Amendments to the Drawings:

REMARKS

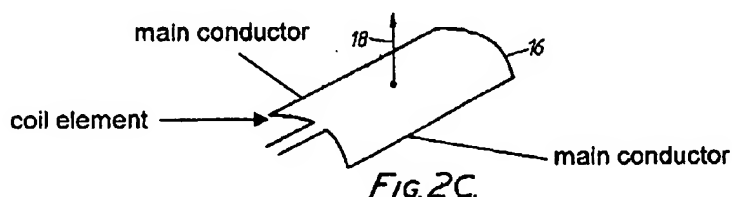
The undersigned then directed the Examiner's attention to the fact that applicants' independent Claim 1 refers to "electrically separate" coil elements, not to electrically connected coil elements. With reference to Fox's Figures 1, 2A, 2B, and 2C, the undersigned further explained that each of Fox's four coil elements has two main conductors. Significantly, the main conductors of those coil elements are not located on "opposite sides" of the space in which the magnetic field is generated as required by Claim 1. Rather, as set forth at column 5, lines 19-22, of Fox and as shown by the following annotated copy of Fox's Figure 2C, these main conductors are separated by 120°:

As such, the main conductors of Fox's coil elements are clearly not opposite to one another as called for by Claim 1, as well as by applicants' other independent claims.
